**U.S. DEPT. OF THE INTERIOR
OFFICE OF SURFACE MINING
Mine Site Evaluation
State Program**

Carbon Junction Mine Partial Oversight Inspection
Colorado Division of Reclamation, Mining and Safety (DRMS) Permit ID # C-1992-080
Tuesday, April 30, 2013, 9:30 p.m. – 2:30 p.m.
Operator: Oakridge Energy, Inc.

Stream Channel and Drainage Reconstruction Evaluation:

Photo ID: 11389
Photographer: SMESHAEFFER
Date Taken: 4/30/2013
State: CO
County: LA PLATA
Latitude: 37.23460861
Longitude: -
107.85084639

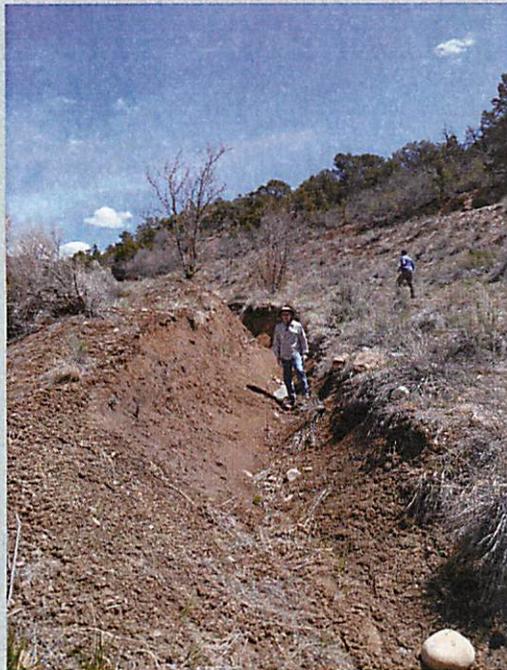
Sediment Pond 2 was inspected. Ms. Talvitie informed us that the dam was removed in 2009. The high banks above Pond 2 are not well vegetated, and the site has historic problems with Canada thistle (Photo 11388). There is not a truly defined channel that carries water from above Pond 2 and meets the original stream, and it is apparent that water collects in a flat, wide area (Photo 11389).

Pond 2 and area in left foreground of photo where water collects

Photo ID: 11390
Photographer: SMESHAEFFER
Date Taken: 4/30/2013
State: CO
County: LA PLATA
Latitude: 37.23489667
Longitude: -
107.85036278

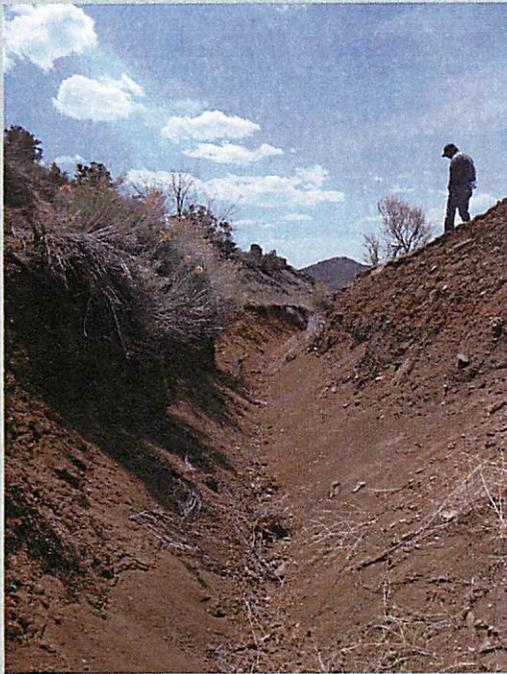
As noted in Item 2 above, the Team observed that the diversion channel located to the left of the original Carbon Junction Canyon drainage (upstream of the reconstructed channel) has erosion and down cutting that has not been reclaimed (Photos 11390 and 11391). The Team walked the entire length of the drainage until the undisturbed, original channel was identified. The Team estimated the depth of this drainage in certain areas to be up to 10 feet. Ms. Talvitie informed us that last fall, she directed the mine operator to eliminate the berm directing the flow to the left of the original Carbon Junction Canyon drainage so that the natural drainage channel could be restored. At the location where the berm was removed, there is a large bare area that should be seeded and mulched to prevent further erosion (Photos 11392 and 11393). The original channel has filled in with vegetation and needs additional work in order to be reestablished to its original condition all the way upstream to the undisturbed natural Carbon Junction Channel and downstream to the reconstructed Carbon Junction Canyon drainage.

Channel is located upstream of reconstructed riprap channel, erosion and downcutting has not been reclaimed.

Photo ID: 11391

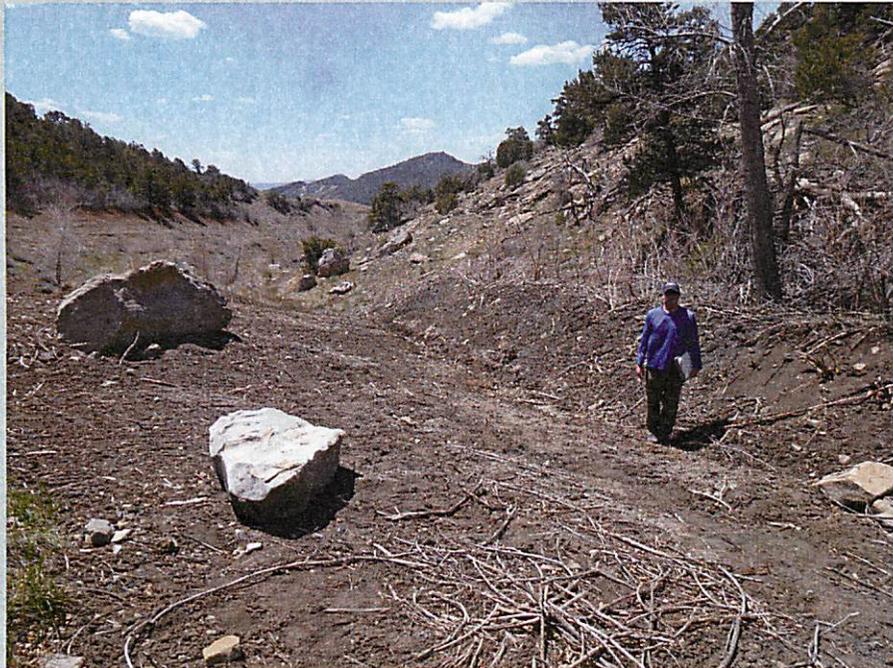
Channel is located upstream of reconstructed riprap channel, erosion and downcutting has not been reclaimed. Photo is taken from floor of gully with person for scale on upper right bank.
